SERVICE BULLETIN

GAME: Secret Service

#010

SUBJECT: BallEater Adjustments

FIGURE 1

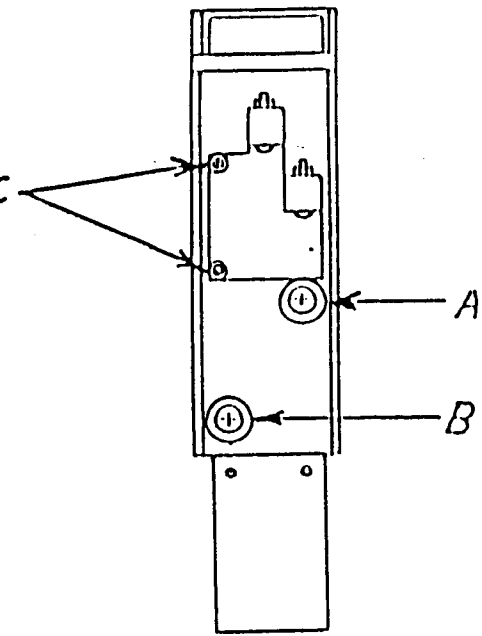
3. Remove 10 turns from the extension spring (fig. 2A).
4. Remove rubber stop from the base of the assembly (fig. 2B).
5. Remove flat washer and star washer from the second screw from the bottom of the housing (fig. 1A).

6. Loosen the two screws holding the switch assemblies (fig. 1C) and the two screws holding the coil assembly bracket (fig. 1A & B).
7. With the ball eater in the down position adjust the coil assembly bracket so the top of the ball eater cube is even with the top edge of the housing (fig. 3A).

8. Tighten the two screws holding the coil assembly bracket (fig. 1A & B).
9. Adjust the switch bracket assembly, so when the ball eater comes down the lower switch "makes" slightly before cube bottoms out (fig. 3B). This allows a wiping motion on the switch to insure the contacts remain clean.

10. Tighten the two screws holding the switch bracket assembly (fig. 1C).
11. Remount the unit to the playfield and install the four screws removed in step 2.
